SUNDRY NOTICES AND REPORTS ON WELLS
Do not use this form for proposals to drill or to re-enter an abandoned well. Use form 3160-3 (APD) for such proposals.

8. Well Name and No.
AAO FEDERAL 27

Apache request to change CSG/CMT/BOP program as follows:
IN THE EVENT CMT IS CIRC TO SURF ON PRIMARY CMT JOB FOR SURF CSG:

CONDITIONS OF APPROVAL

Eddy County, New Mexico
Sec 1, T18S, R27E
AAO Federal #27
Quote 140592
Design #5

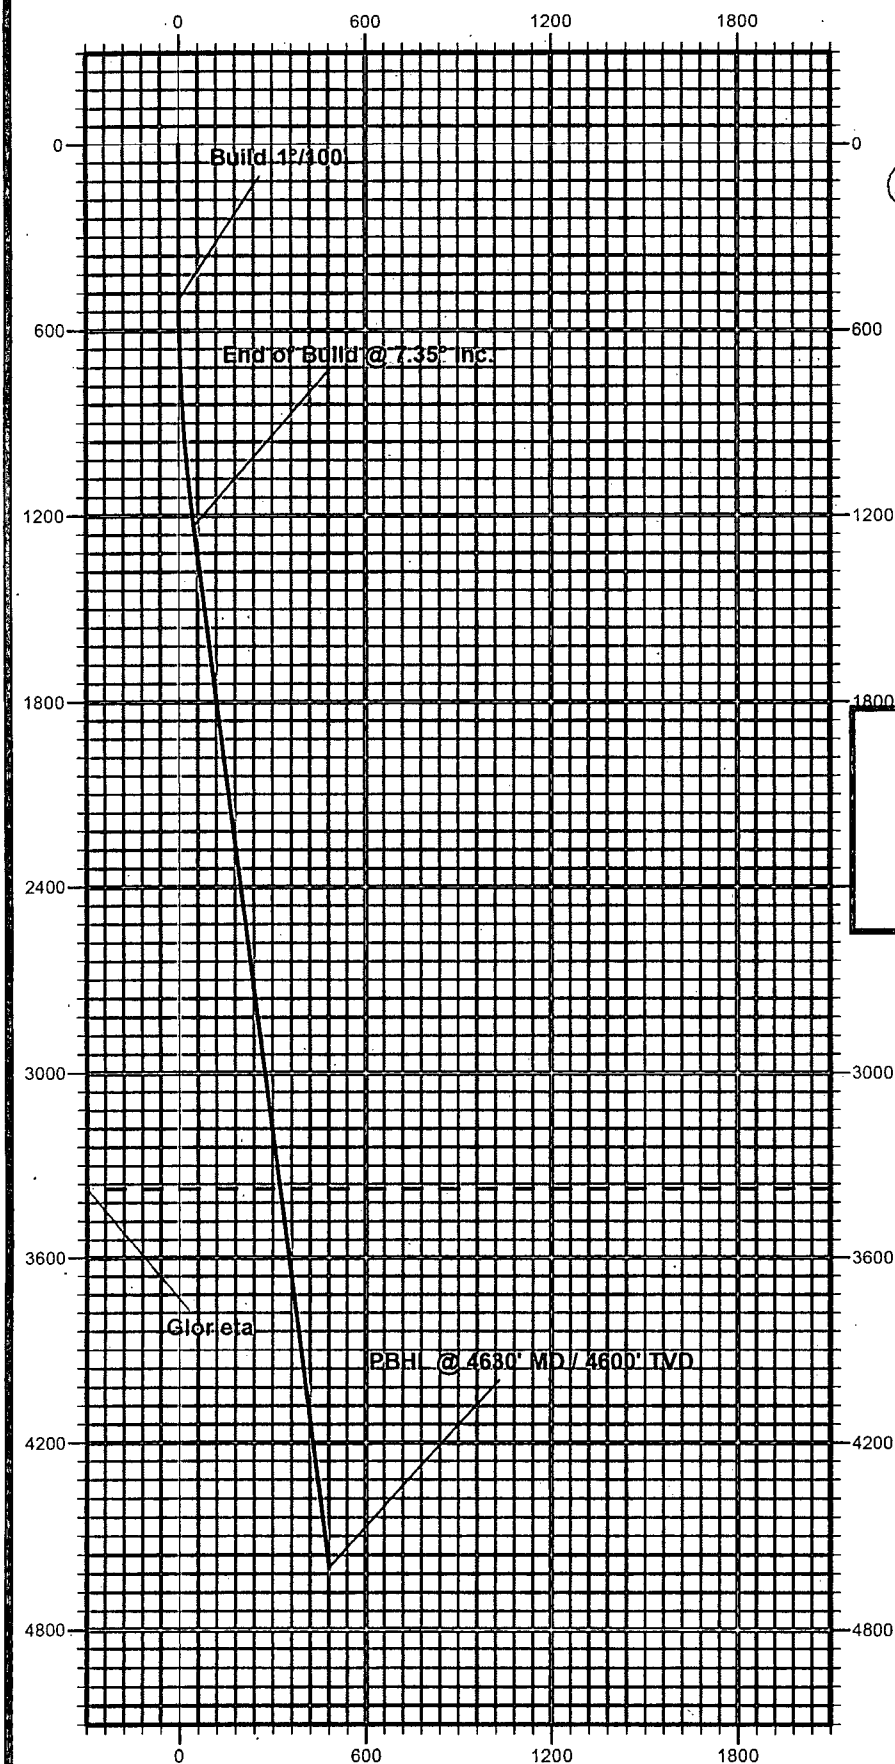
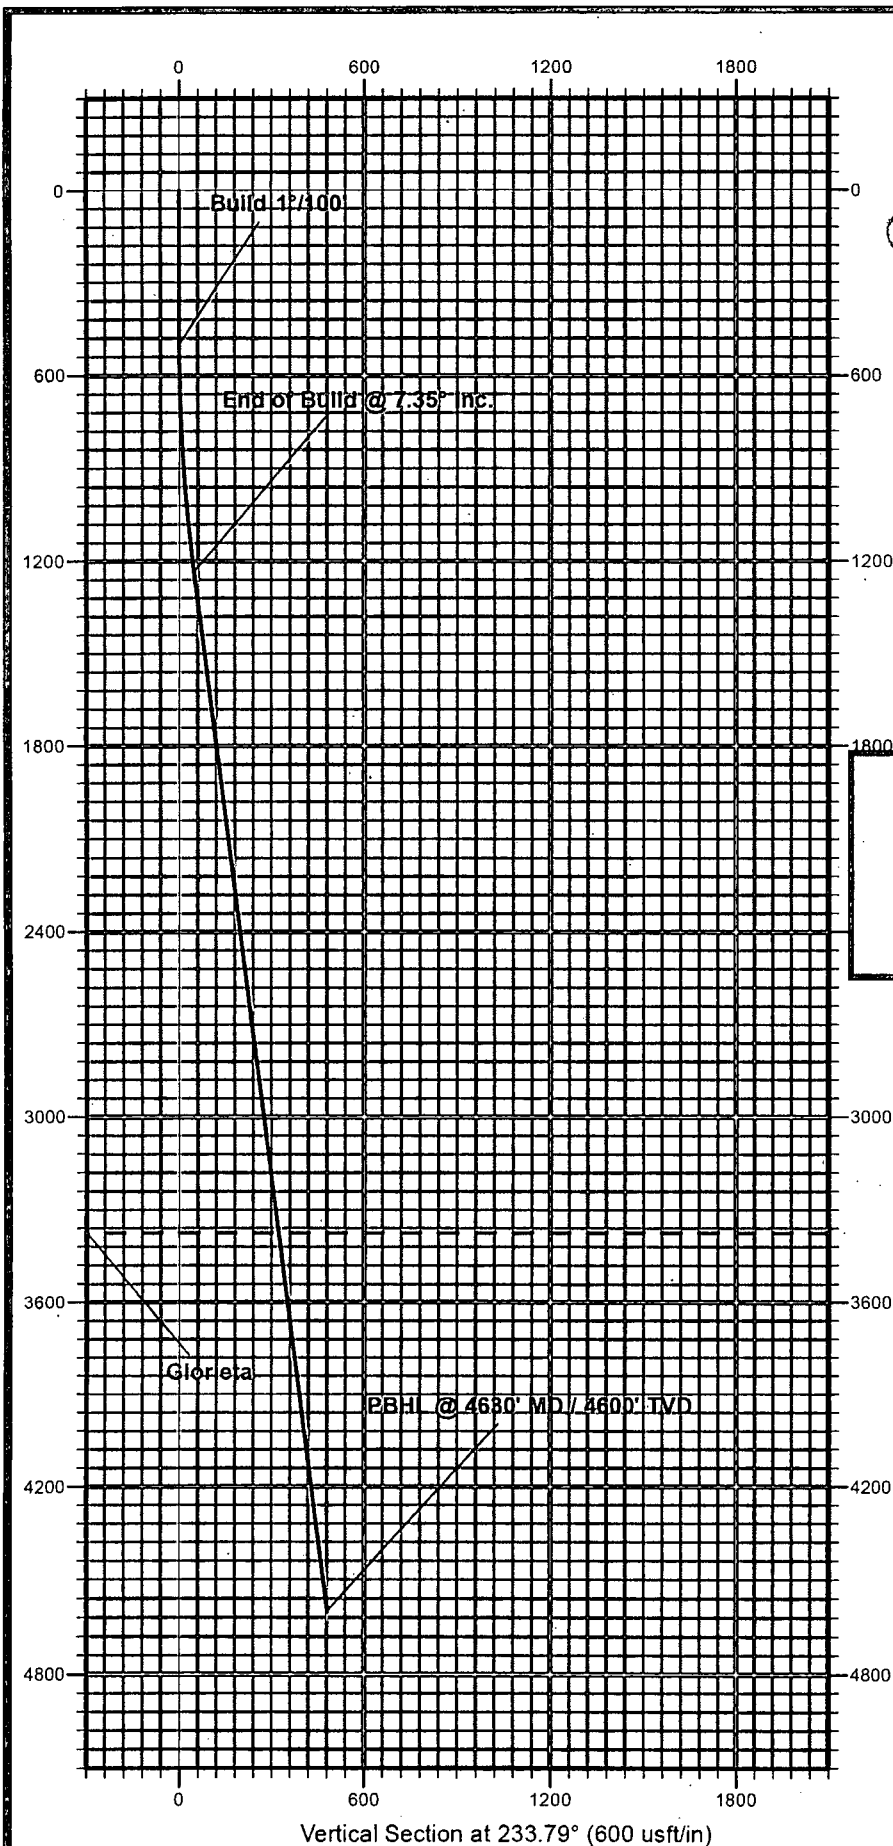
Rest of CMT PROGRAM & PROPOSED CONTROL EQUIP on attachment due to lack of space. Have also added a new directional plan.
